## CITY OF TORONTO DESIGN REVIEW PANEL

### MINUTES: MEETING 3– April 21, 2017

## 2442 – 2454 BLOOR ST WEST and 1-9 RIVERVIEW GARDENS

# YONGE- EGLINTON BUILT FORM STUDY

2 RIVERVIEW GARDENS - Current Revised Proposal

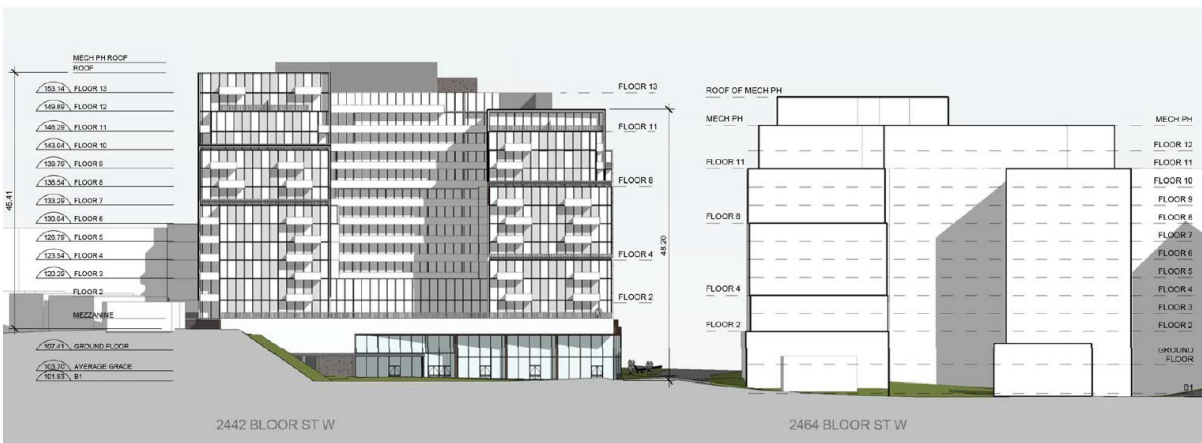
-remove the protruding balconies and provide inset ones as per the first design, "the previous one without protruding balconies was more successful. It's the underside of balconies that make it a busy façade".

A more vertical expression was encouraged to be looked at on the east façade as per the previous scheme, by several Panel members, to respond to the view terminus. "In this view there is just a flanking wall...the return is very big and bulky. Look at if you don't return and have a more vertical expression."

A Panel member advised that while the stepping in the massing helps, and there has been a lot of good work done, "the bottom line is that the building is still too tall". Several members raised concerns with the overall height which although reduced "is still 54m" where mid-rise guidelines allow for 30m. A Panel member noted that there is strength in the massing changes, but the building is "just too tall for the site".

## C2. REDPATH PARK STREET LOOP ELEVATION ALONG ROEHAMPTON AVENUE LOOKING SOUTH EMERGING DIRECTION (2041)

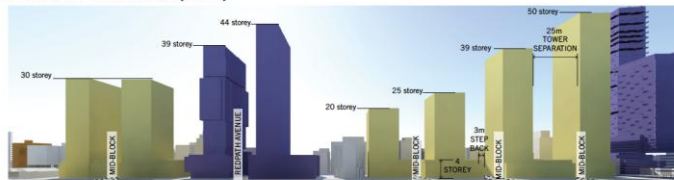
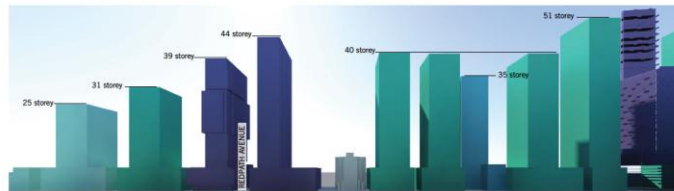
The diagrams comparing the status quo and emerging directions were commended by many Panel members. "The diagrams are brilliant...The power and strength of studies allow us to imagine how the public realm and liveability of the area will be built out." In comparing the proposed directions versus the status quo, panel members were supportive of the improved liveability conditions:  
-solar access improvements were commended  
-the improvements in skyviews were noted to be good in that they provide significantly more sky view than the status quo

It was also observed that the 25m separation between towers is uniformly shown in the drawings when it is actually a minimum dimension in existing guidelines. The consistent use of this minimum separation in the diagrams contributes to the issue and should be remedied.

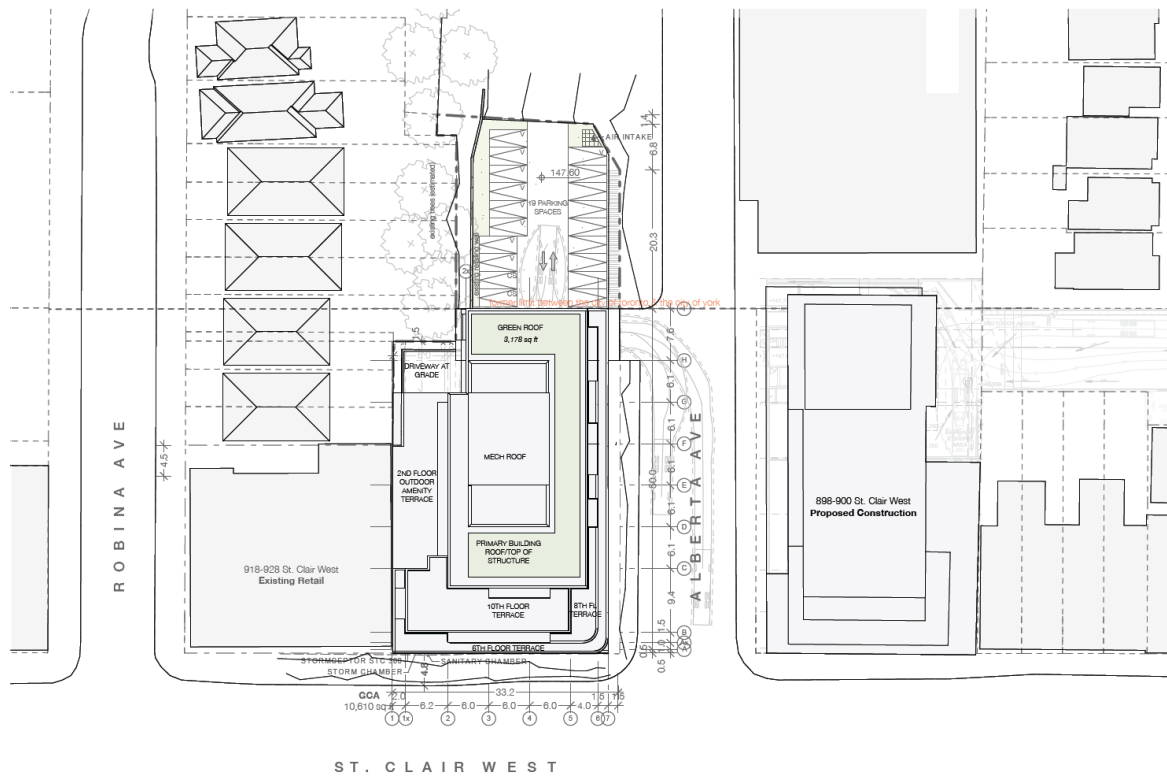
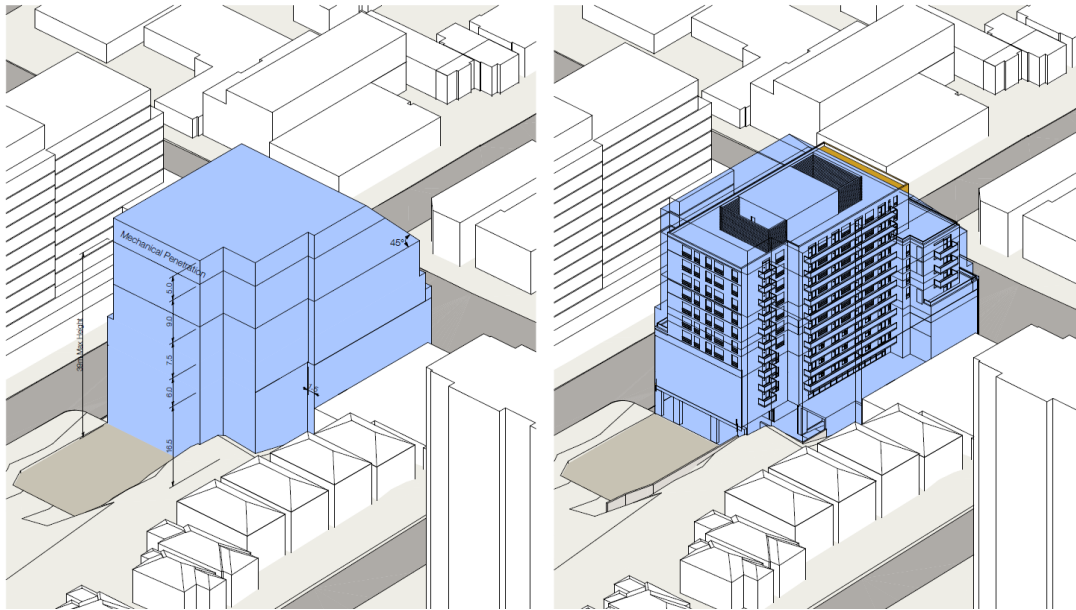
- Provide as much setback as possible on St Clair Ave West:

Several Panel members commented that while the St Clair public realm is good, there should be as much breathing room as possible at ground level. The building façade should be pushed back from St Clair to align with the adjacent west building which appears to be 0.3m-0.6m to the north, and will be an impactful change due to the pedestrian activity being located there.

**CHERRY SQUARE PLAN**

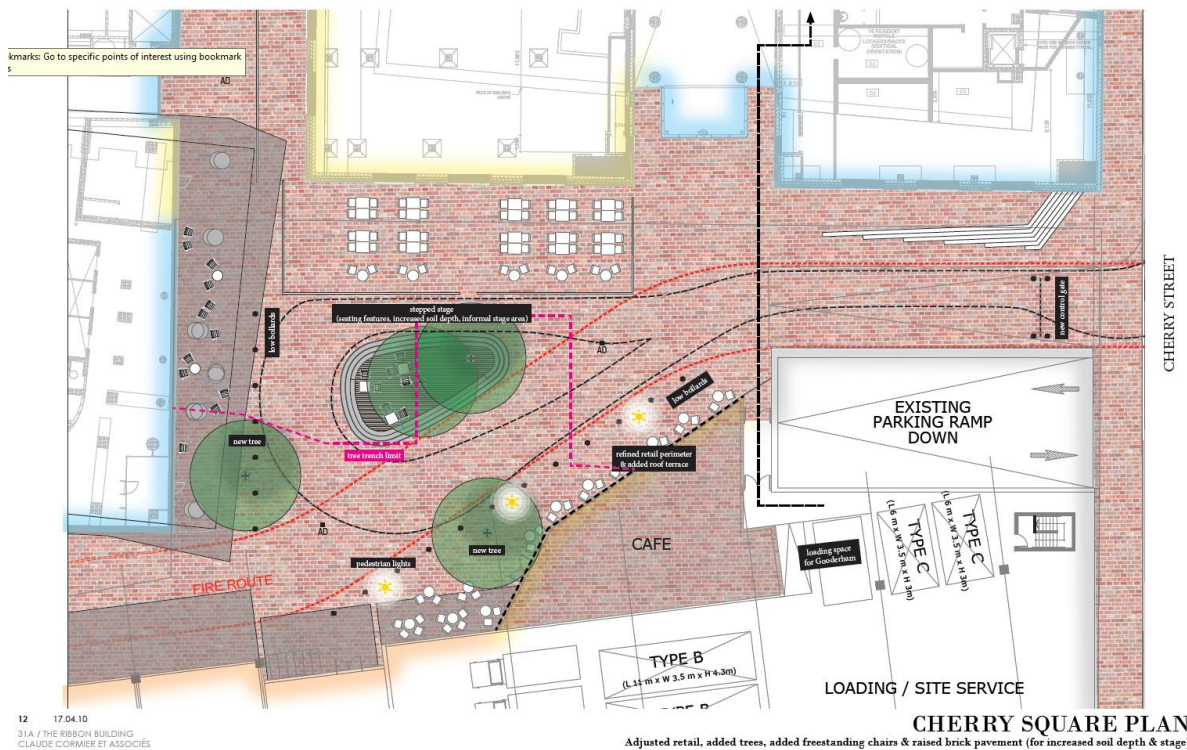
While recognizing the constraints of soil depth, many members advocated for as much planting and greenery as possible. A suggestion was to add a strip of planting on the north wall of garage will green the wall and help mitigate the "relentless brick everywhere".

A Panel member advised that while bollards are not desirable, there should be a subtle indication of where pedestrians should stand when vehicles come through the square.
